Rezoning Transportation Analysis

Petition Number: 2024-090

From: Jake Carpenter, PE
Jacob.Carpenter@charlottenc.gov
980-221-5675

| Revision Log: | Date | Description |
|---------------|----------|--------------------|
| | 12-02-25 | Third Review (DR) |

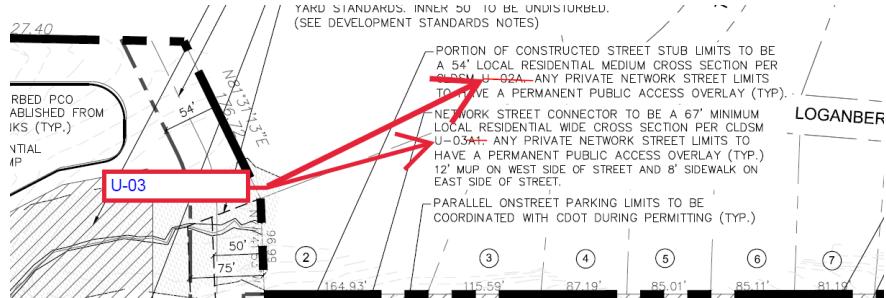
6. ~~Coordinate with subdivision regarding public roadway requirements. Revise site plan and conditional note(s) to reflect coordination.~~

7. ~~Revise site plan and conditional note(s) to commit to revising Access #2 to be Right-In only with 100 feet of storage along with appropriate deceleration lane and 250 foot taper. Access #2 is to be skewed 65 degrees. Access #2 is to be 17 feet BOC to BOC through internal protected stem.~~

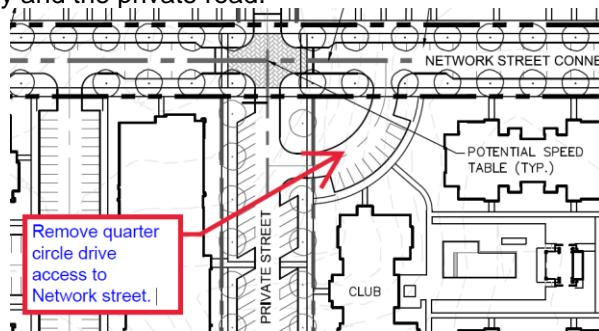
10. Revise site plan and conditional note(s) to commit to installing an 8-foot sidewalk with an 8-foot planting strip along Galloway Road frontage per UDO table 32-4.

11. Revise site plan and conditional note(s) to commit to removing the quarter circle connecting the internal network required roadway and the private road.
